Baldwin County Planning Commission Staff Report

Case No. SC25-13 Replat of Lot 5 Cypress Hollow June 5, 2025

Request: Preliminary plat approval for residential subdivision

Parcel Number: 05-32-02-10-0-000
SMALLEST LOT: 4.50 Acres
LARGEST LOT: 3.91 Acres

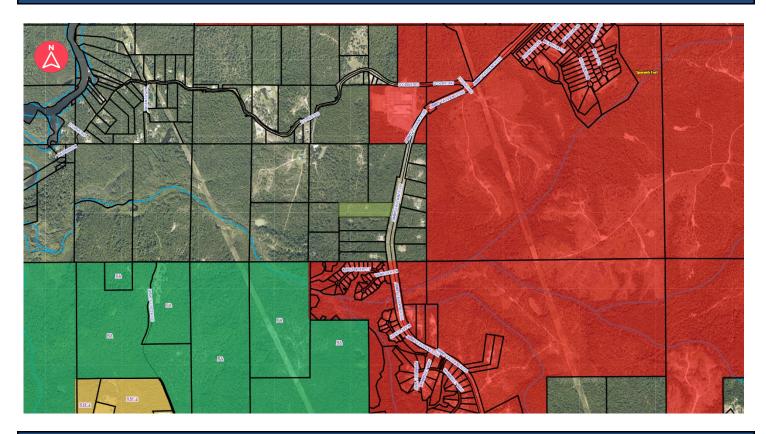
- 1. Correct smallest and largest lot sizes in data table.
- 2. Add wetland setback to site date table as 30' Natural Buffer
- 3. Add a note stating that any improvements to the existing culverts and access near the jurisdictional wetlands will require permitting from the U.S. Army Corps of Engineers.
